Service Bulletin: SB412-304 BG; Bell 412 Air Conditioner System

Subject: Installation of Belt Guard & Improved Idler Bearing – M412 Cabin Air Conditioning System.

Date: August 22, 2003

Applicability: Bell Helicopter Models 412, 412EP, 412HP, 412SP equipped with the Air Comm Corporation Air Conditioner System.

Figure 1, 412EP & 412HP Compressor Installations

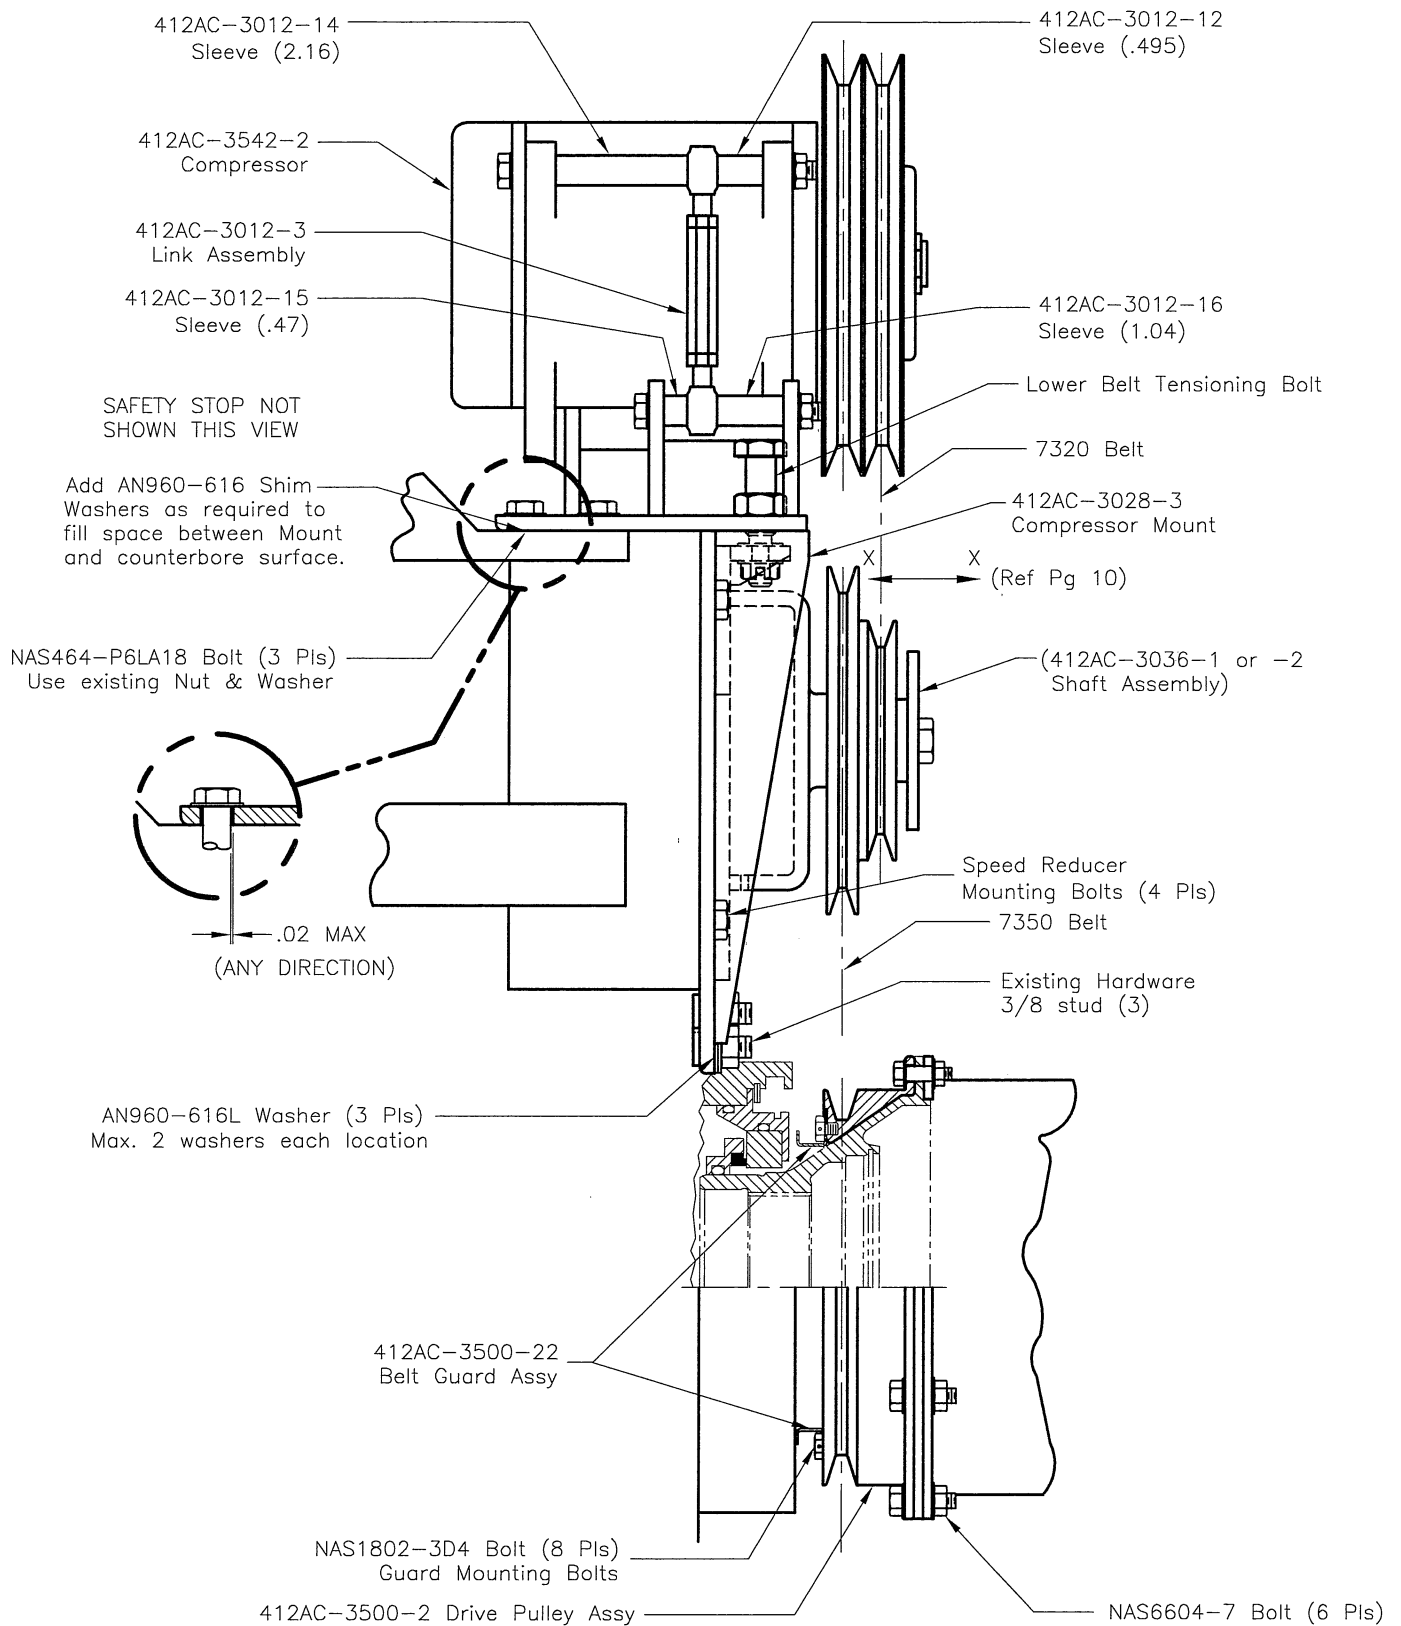
XIII Installation Of Belt Guard Ring (Figures 1 & 2)

1. Removal of the existing Ring Segments from the Compressor Pulley.
 - A. Cut the safety wire and remove the eight (8) Bolts from the forward surface of the Compressor Drive Pulley, and remove Ring Segments.
2. Installation of the new Belt Guard Ring.
 - A. Install the new Belt Guard Ring, using eight (8) NAS1802-3D4 (provided) Bolts to the forward surface of the Compressor Drive Pulley. Tighten the bolts and safety with .032 Safety Wire.

Inspection is to be accomplished by application of a 2 to 3 lb. (.9 to 1.4 Kg) force to the edge of the pulley as shown by figure 1. Any free-play of the pulley/bearing assembly in the direction X-X is cause for immediate replacement of the bearing.

Figure 2, 412 & 412SP Compressor Installations

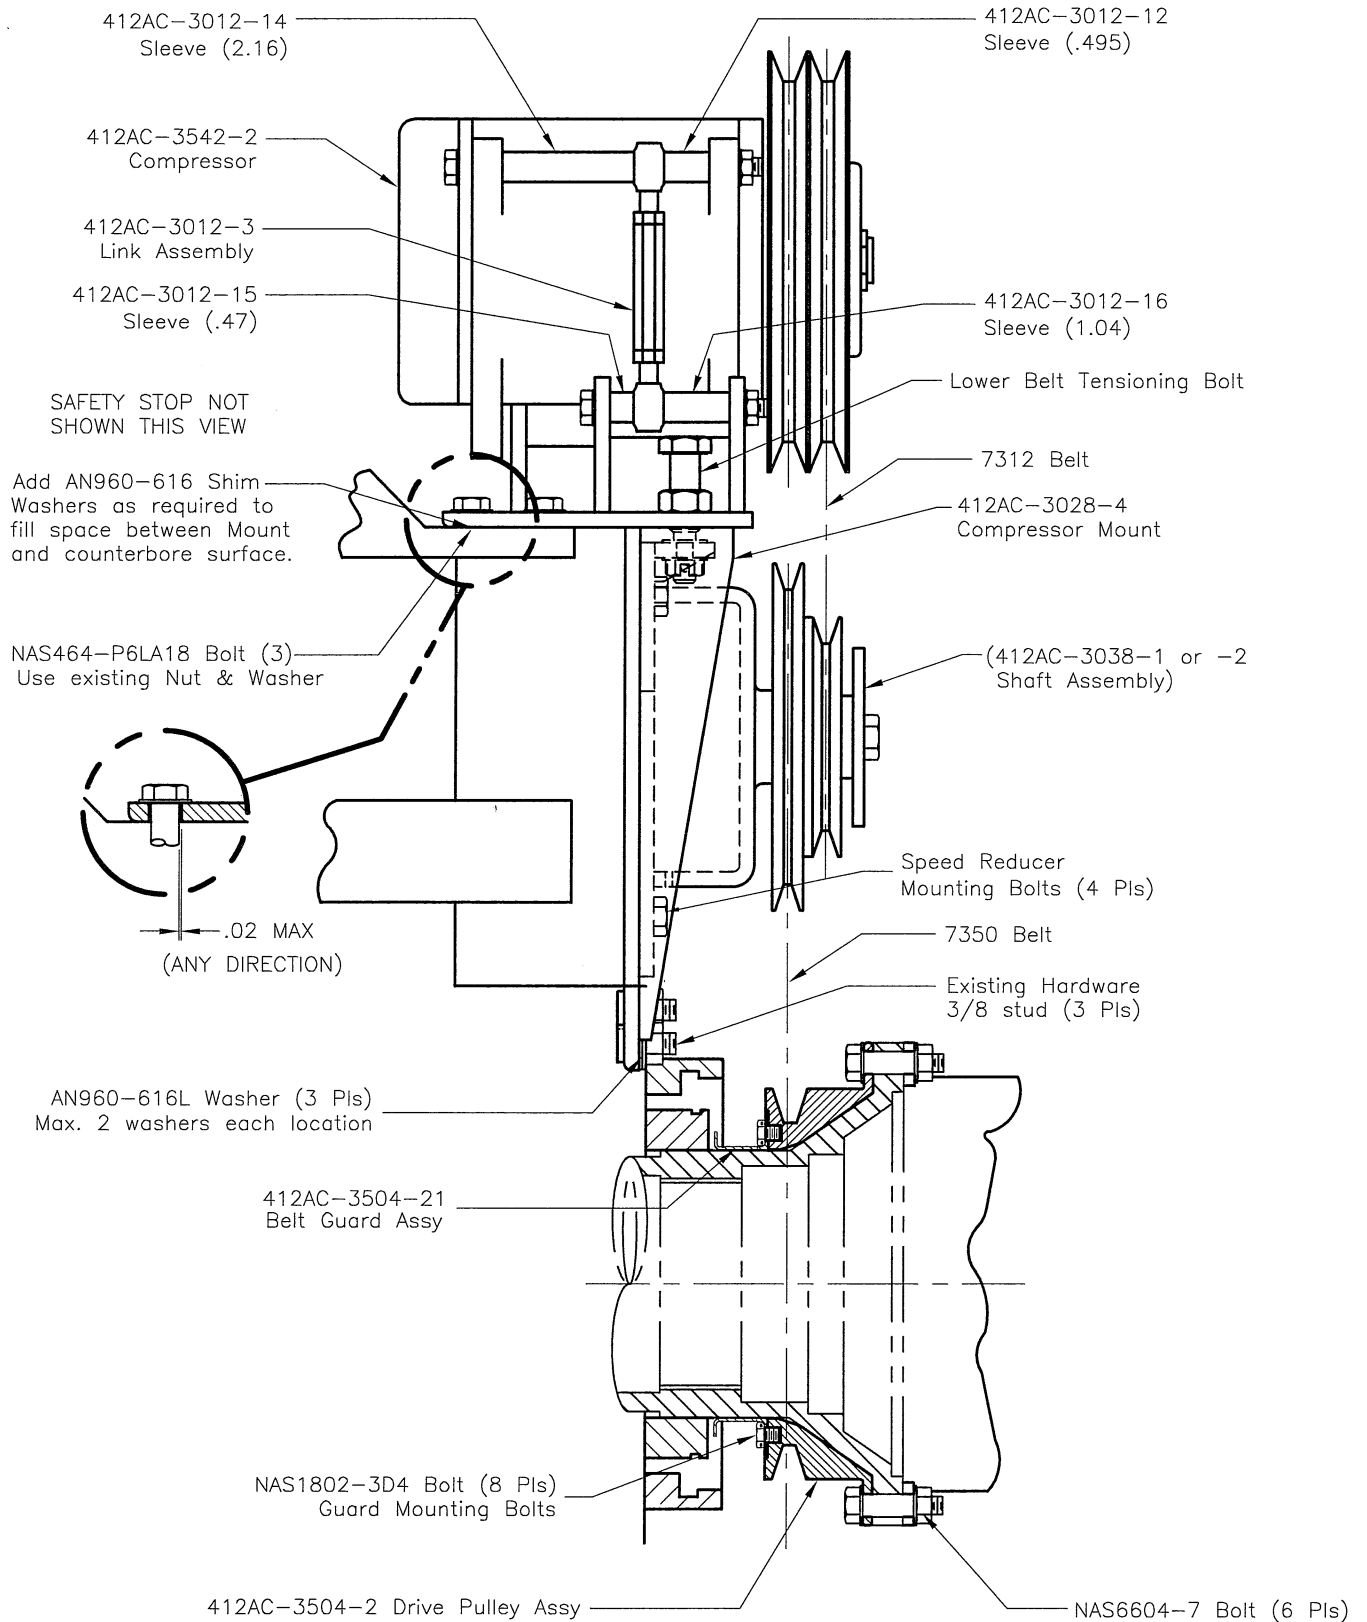
2. Reinstall the two AN960-616 Washers between the top of the Speed Reducer Assy. and the bottom of the Compressor Mount, reinstall the AN320-6 Nut, and AN380-3-3 Cotter Pin in the bottom of the 412AC-3016-16 Bolt (figure 2).
3. Reinstall the lower drive belt on the Drive Pulley and to the inner race of the Speed Reducer Pulley.

Figure 3, 412AC-3500 & 412AC-3504 Drive Pulley Belt Guard Installation

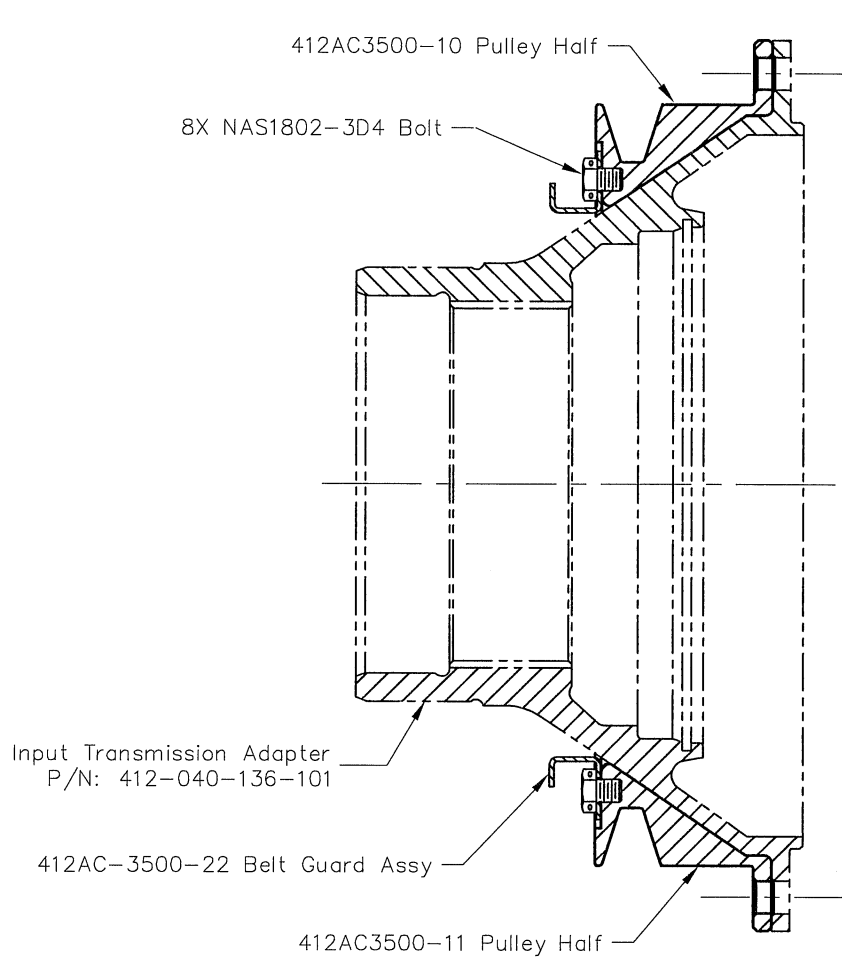
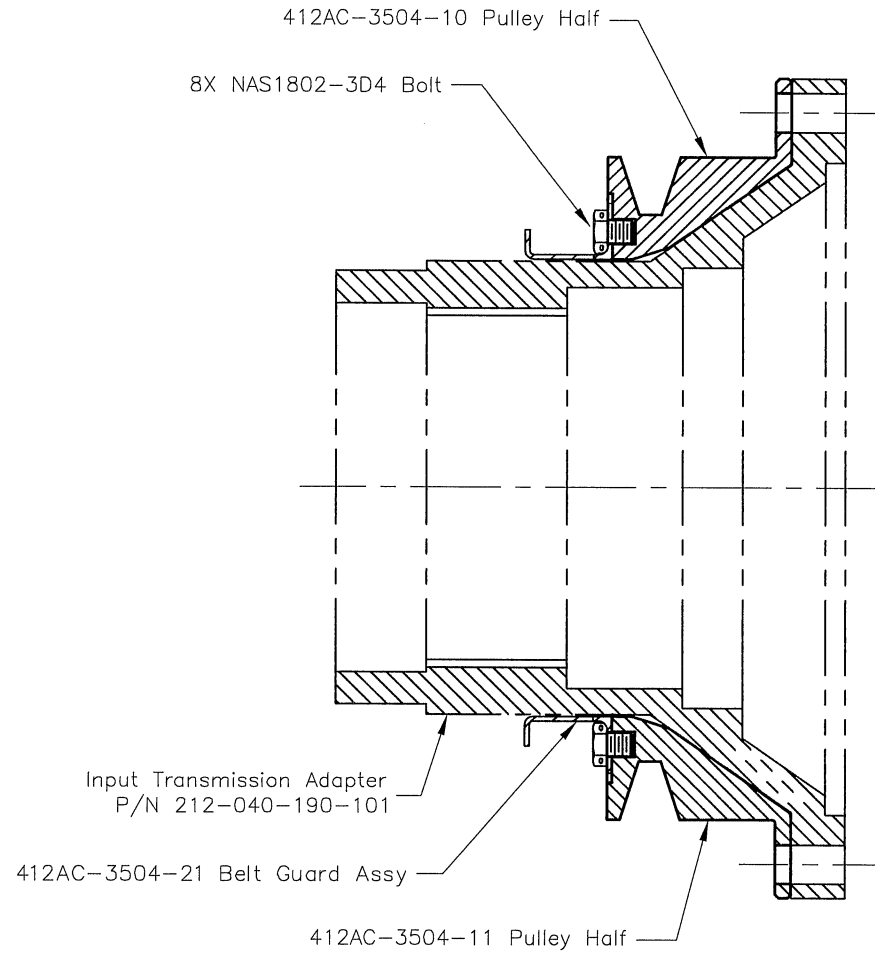
This Service Bulletin provides for the installation of “Flanged Ring Segments” to the forward surface of the Compressor Drive Pulley, to prevent the Compressor Drive Belt(s) from becoming lodged in this area.

Figure 4, 412 Air Conditioner Compressor Mount and Speed Reducer Assembly

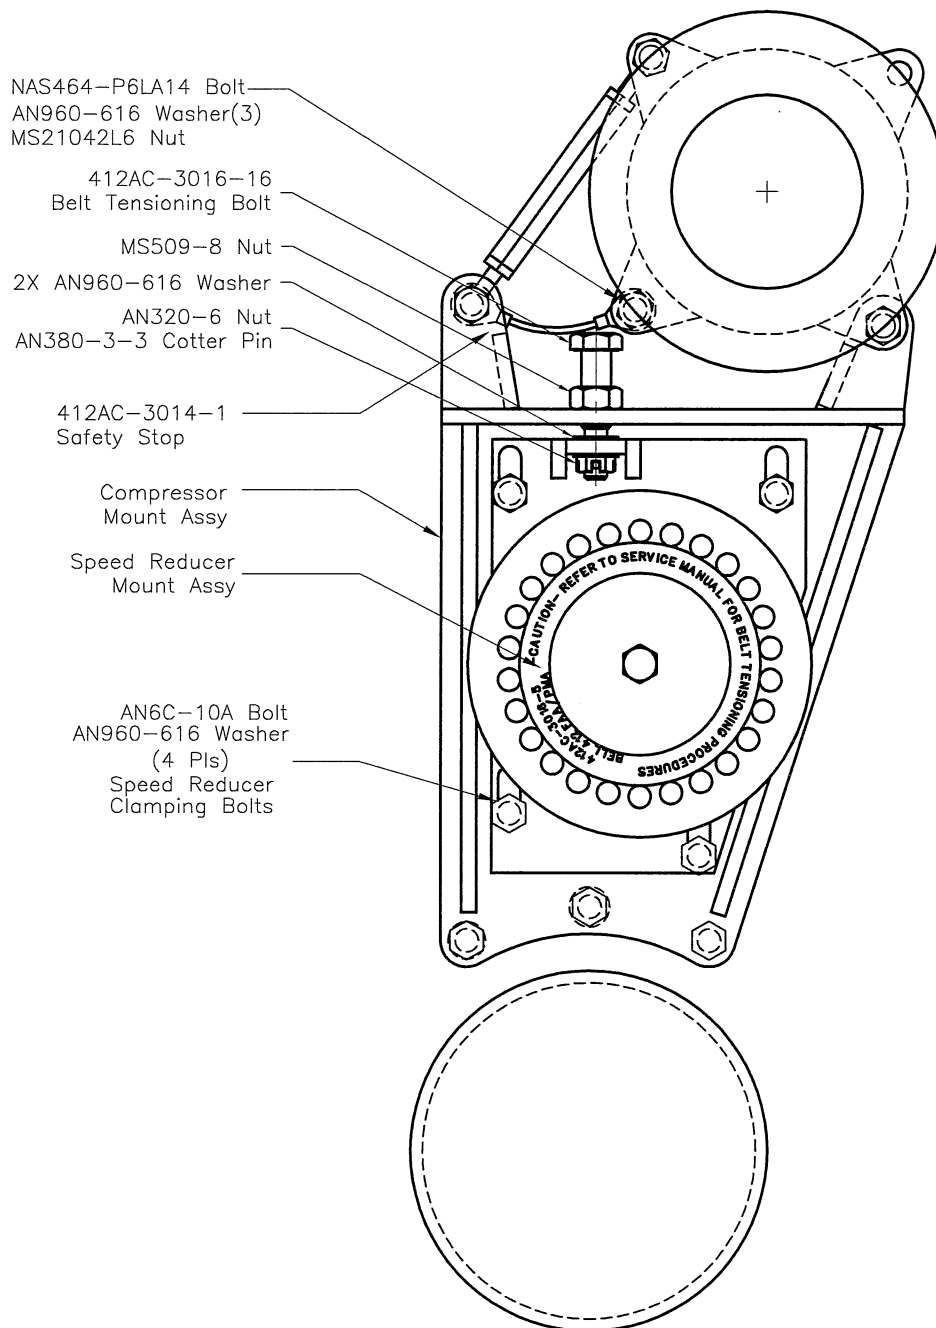
X Removal of Speed Reducer Assembly (see figure 4).

3. Remove the bottom Compressor Drive Belt by loosening the four AN6C-10A speed reducer clamping bolts, and the Speed Reducer Belt Tensioning bolt 412AC-3016-16 on the top of the Compressor Mount Assy (see figure 4).

5. Remove the four AN6C-10 Bolts from the face of the Speed Reducer Pulley / Shaft Assembly, and remove the assembly from the aircraft (figure 4).
6. Remove MS21043-6 Nut from AN6C-10A Bolt in center of the Speed Reducer assembly (figure 5).
7. Remove AN6C-10A, 412AC-3036-13 Bevel Washer, 412AC-3036-14 Retainer Plate (figure 5).
8. Remove N5000-218PP Snap Ring from Speed Reducer Shaft.
9. Remove 412AC-3016-4 Pulley Assembly from the Speed Reducer Shaft.

1. Reinstall the four AN6C-10A Bolts through the slots in the Speed Reducer Shaft assembly, into the Nutplates located in the Compressor Mount (figure 4).

4. Torque the four AN6C-10A Bolts in the face of the Speed Reducer Assy. to 95 – 110 in-lbs.
5. Tighten the MS509-8 Jam Nut on the 412AC-3016-16 bolt, and safety using .032 safety wire (figure 4).
6. Reinstall the upper drive belt on the outer race of the Speed Reducer pulley, and the outer race of the Compressor Pulley. Using the Belt Tension Link located on the top of the compressor, tension the belt to 61 lbs. of tension. Safety the Belt Tension Link using .032 safety wire.

Figure 5, 412 Air Conditioner Speed Reducer Assembly

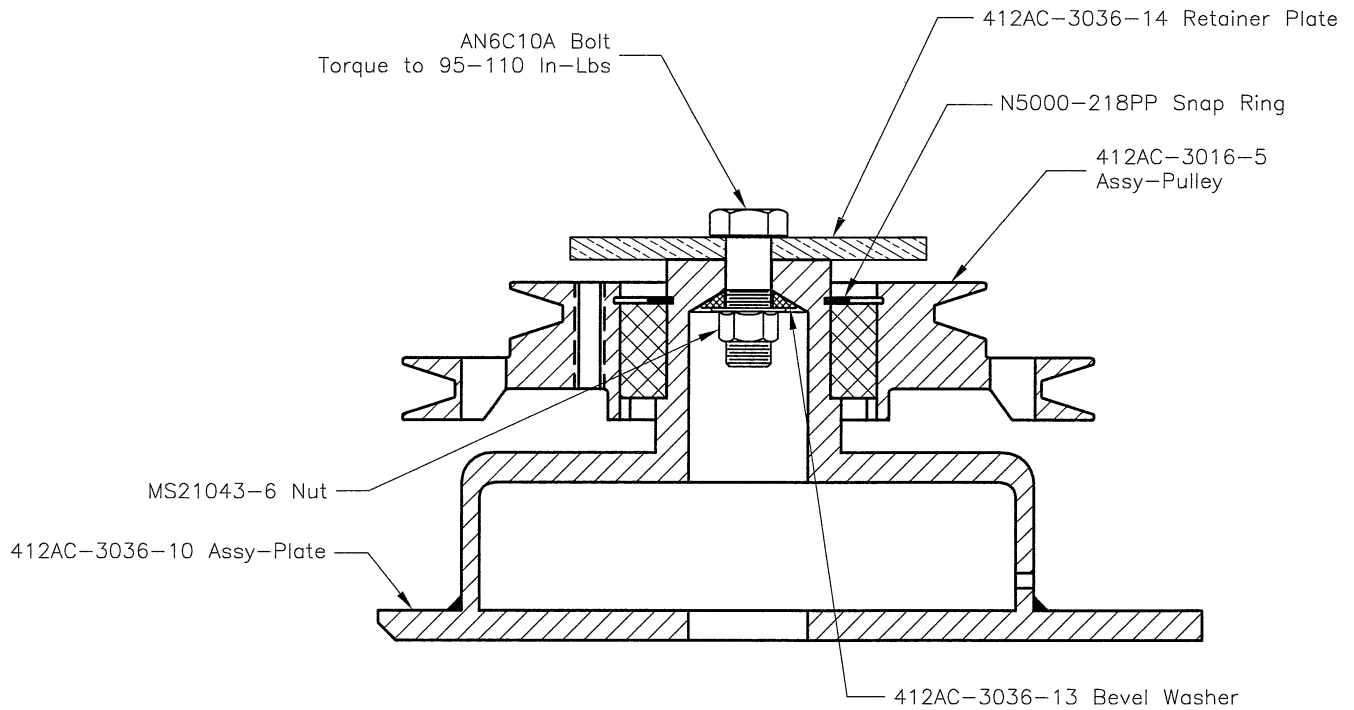
4. Reinstall the AN6C-10A Bolt, 412AC-3036-14 Retainer Plate, 412AC-3036-13 Bevel Washer, and MS21043-6 Nut on the Speed Reducer Shaft, and torque the MS21043-6 Nut to 95 – 110 In-lbs (see figure 5).
5. Rotate Pulley to check for smooth and noise-free operation.

5. Reinstall the AN6C-10A Bolt, 412AC-3036-14 Retainer Plate, 412AC-3036-13 Bevel Washer, and MS21043-6 Nut on the Speed Reducer Shaft, and torque the MS21043-6 Nut to 95 – 110 In-lbs (figure 5).

Figure 6, Speed Reducer Pulley and Bearing Assembly

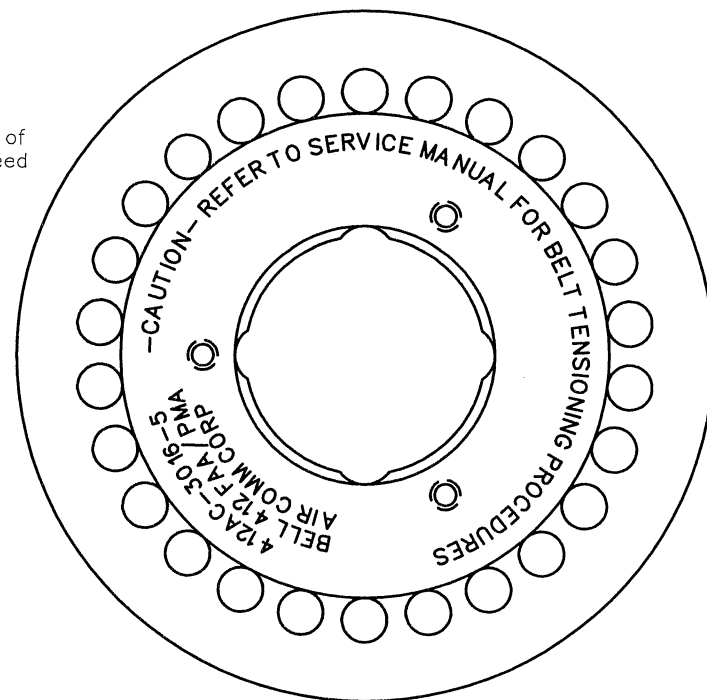
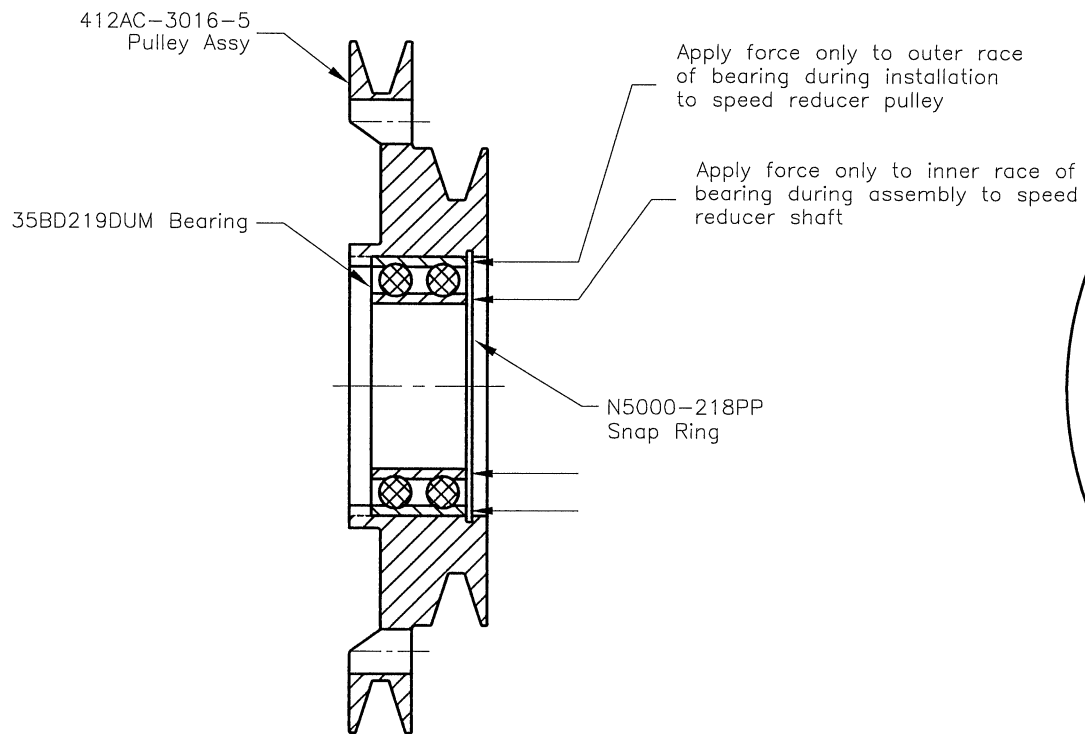
3. Install new 412AC-3016-5 Pulley / Bearing on to the Speed Reducer Shaft (see figure 6).

1. Accomplish the requirements of Section X.
2. Remove and discard previously installed Bearing (see Items X-10 and X-11).
3. Install new Bearing on to the Pulley (see figure 6), and re-install Snap Rings.
4. Install Pulley Bearing Assembly on to the Speed Reducer Shaft (figure 6).
